Hungarian proposals for the discussion of draft new REC regulation (Version REC 10-02)

Arrangement of the REC type approval mark

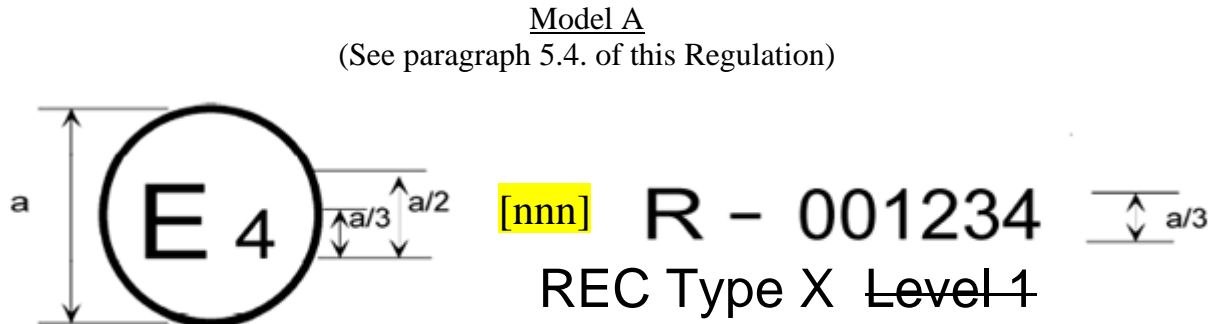
The above example approval mark affixed to a Retrofit Emission Control device (REC) shows that the type concerned has been approved in the Netherlands (E 4), pursuant to Regulation No. [nnn] under approval No. 001234. The first two digits of the approval number indicate that the approval was granted in accordance with the requirements of Regulation No. [nnn] in its original form. The approval mark shall also show the Type of REC (I, II, III or IV) ~~and its Reduction Level~~
